Pre-Application Report

Case Number / AMANDA No. PRE-AP23-25 / 23-105449-PA
Conference Date March 20, 2023
Applicant Leonard Lodder
Studio 3 Architecture
275 Court Street NE
Salem, OR 97301
leonard@studio3architecture.com
Representative Leonard Lodder
Case Manager Bryce Bishop

Project Description	Proposed mixed-use development consisting of retail and residential on a portion of the former Fairview Training Center site.
Property Address	2110 Strong Road SE
Assessor's Map and Tax Lot Number	083W11AB03200
Property Size	Approximately 1.08 acres
Existing Use	Vacant lot
Comprehensive Plan Map Designation	Mixed Use
Zoning	FMU (Fairview Mixed-Use) and within the Fairview Refinement Plan II refinement plan
Overlay Zone(s) / Historic Districts	None
Urban Service Area	The subject property is located outside the City's Urban Service Area. Note: When property is located outside the City's Urban Service Area an Urban Growth Preliminary Declaration is required for development of the property. Urban Growth Preliminary Declarations (Case Nos. UGA04-08 & UGA04-08A) were previously approved for development of this portion of the former Fairview Training Center site. An Urban Growth Preliminary Decl

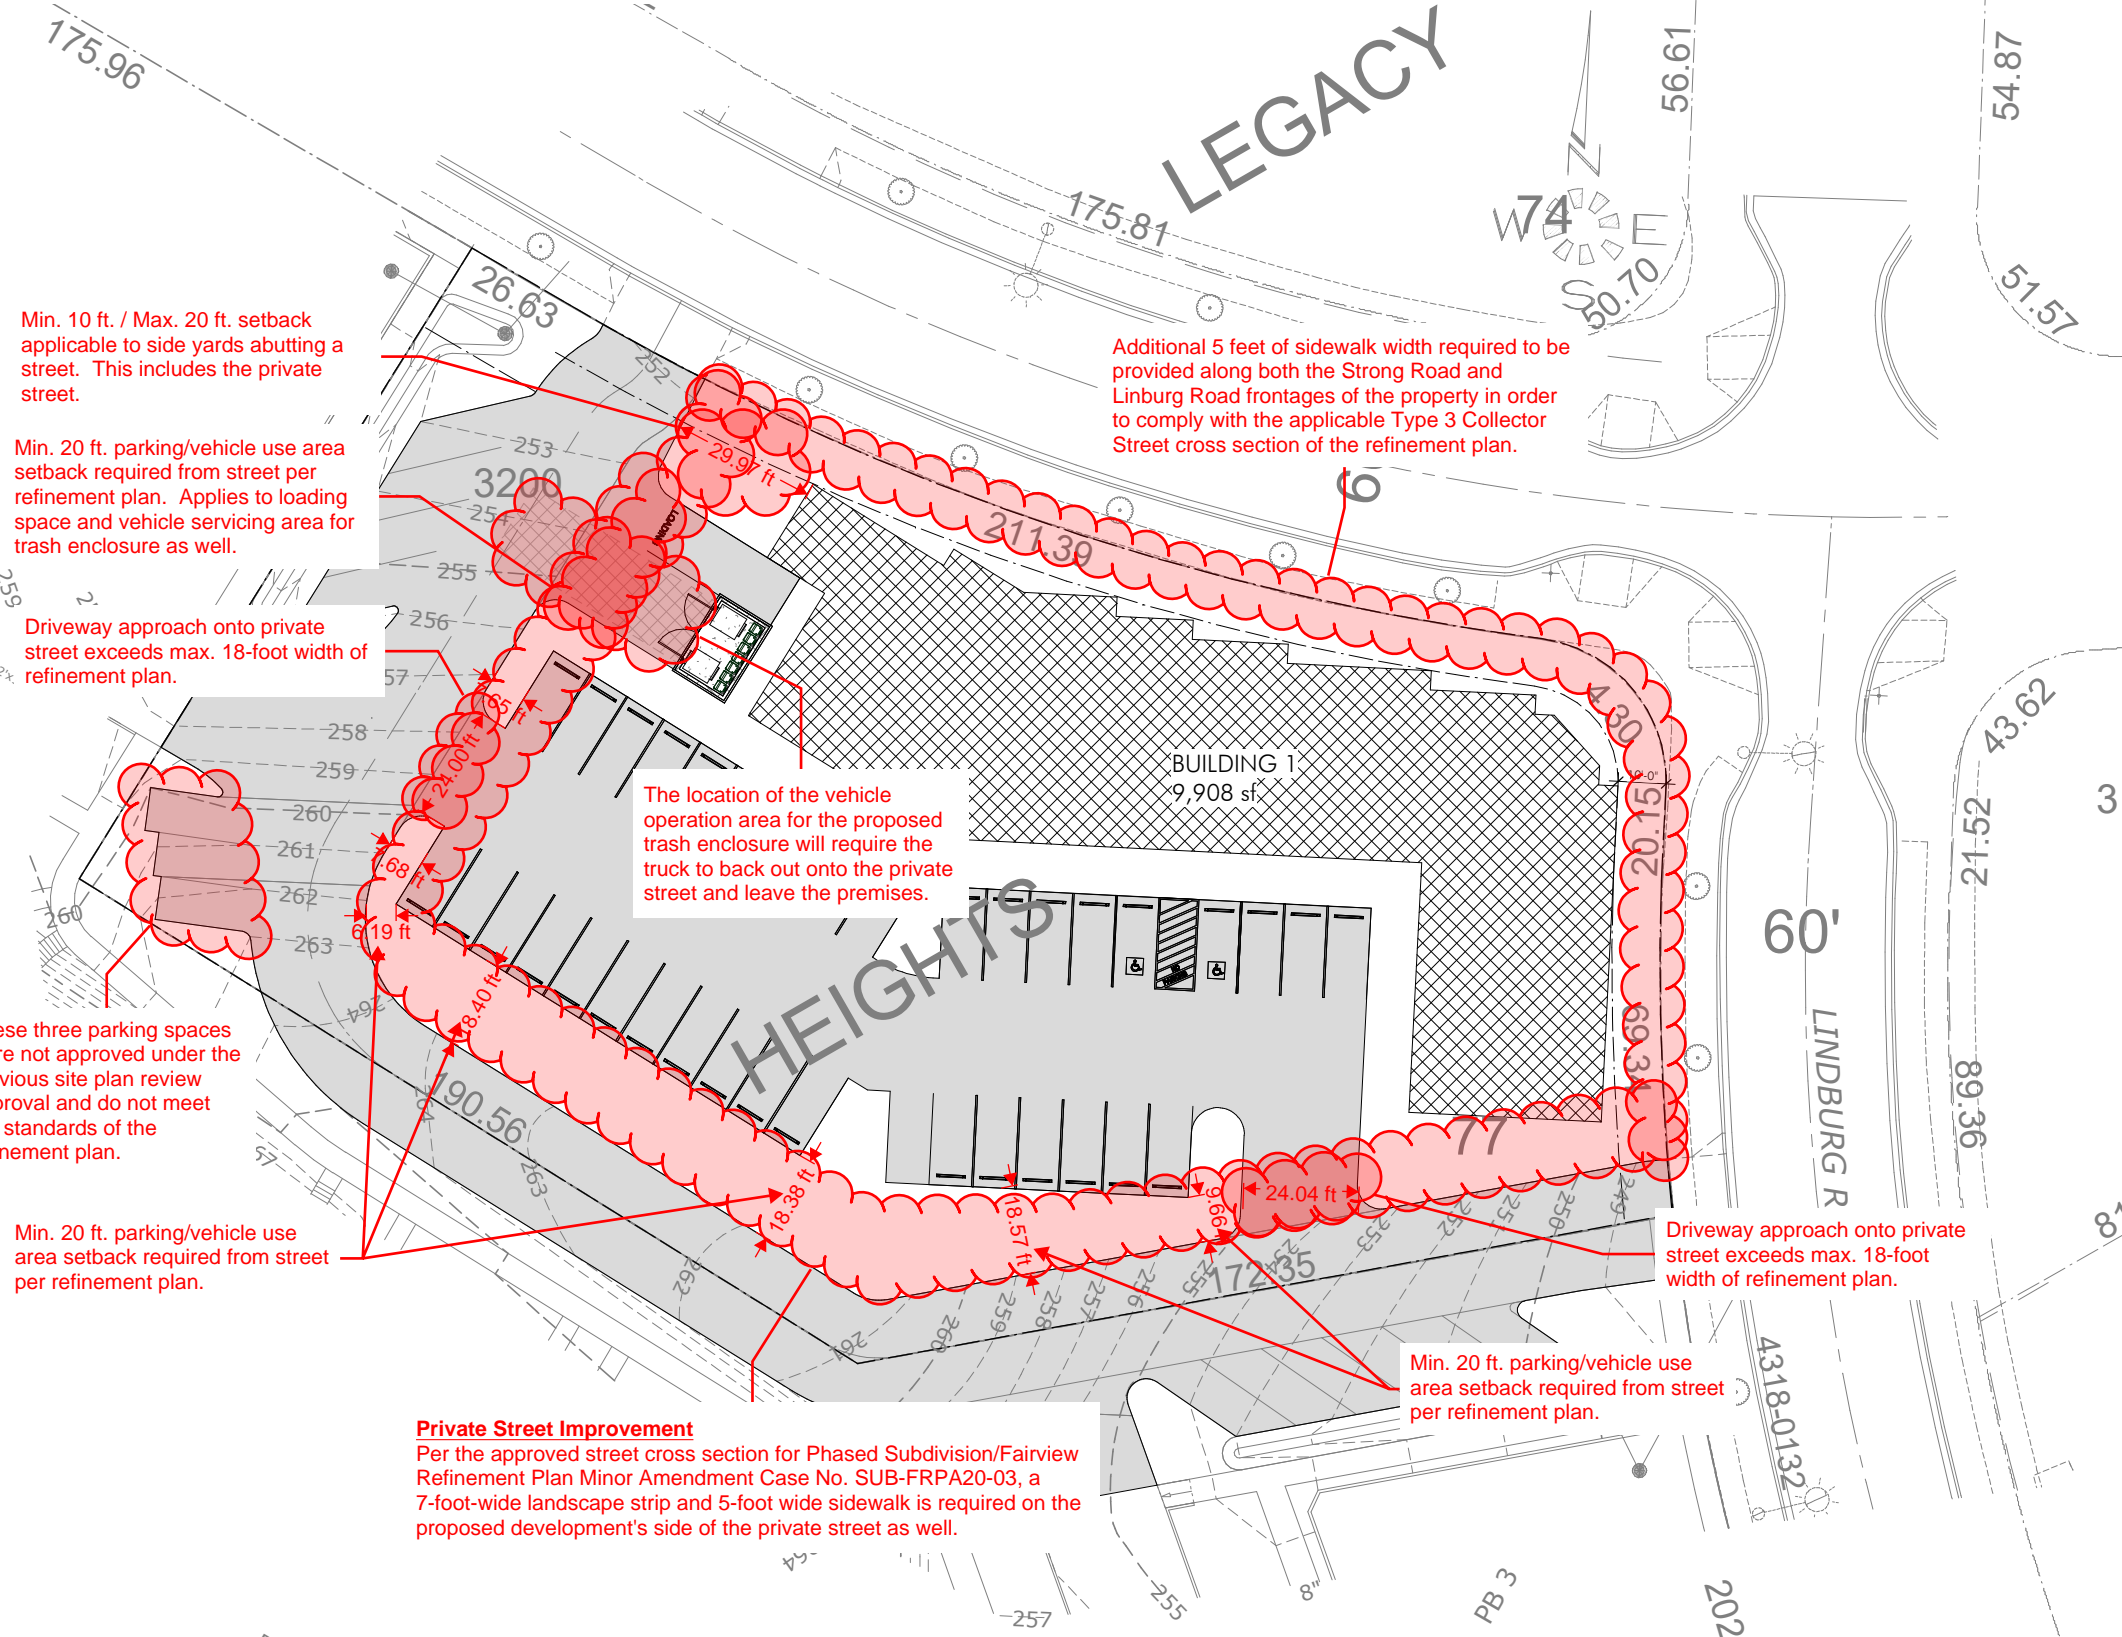
- ☐ SAMPLE SITE PLAN NOTE
- Strong & Lindburg Road Building Frontage:**
Min. 70 percent of lot frontage required to be occupied by buildings placed at the setback line along Strong Road and Lindburg Road.
- Bike Parking**
-Min. 1 per unit (Residential): 9 units x 1 = Min. 9 spaces
-Min. 1 per 500 ft.² (Non-Residential): 9,908 ft.² / 500 ft.² = 19.8 or Min. 20 spaces
-Total Min.: Min. 29 spaces
-No bike parking spaces currently identified on plan.

Min. 20 ft. parking/vehicle use area setback required from street per refinement plan. Applies to loading space and vehicle servicing area for trash enclosure as well.

Driveway approach onto private street exceeds max. 18-foot width of refinement plan.

Additional 5 feet of sidewalk width required to be provided along both the Strong Road and Lindburg Road frontages of the property in order to comply with the applicable Type 3 Collector Street cross section of the refinement plan.

These three parking spaces were not approved under the previous site plan review approval and do not meet the standards of the refinement plan.

Min. 20 ft. parking/vehicle use area setback required from street per refinement plan.

Driveway approach onto private street exceeds max. 18-foot width of refinement plan.

Min. 20 ft. parking/vehicle use area setback required from street per refinement plan.

Private Street Improvement
Per the approved street cross section for Phased Subdivision/Fairview Refinement Plan Minor Amendment Case No. SUB-FRPA20-03, a 7-foot-wide landscape strip and 5-foot wide sidewalk is required on the proposed development's side of the private street as well.
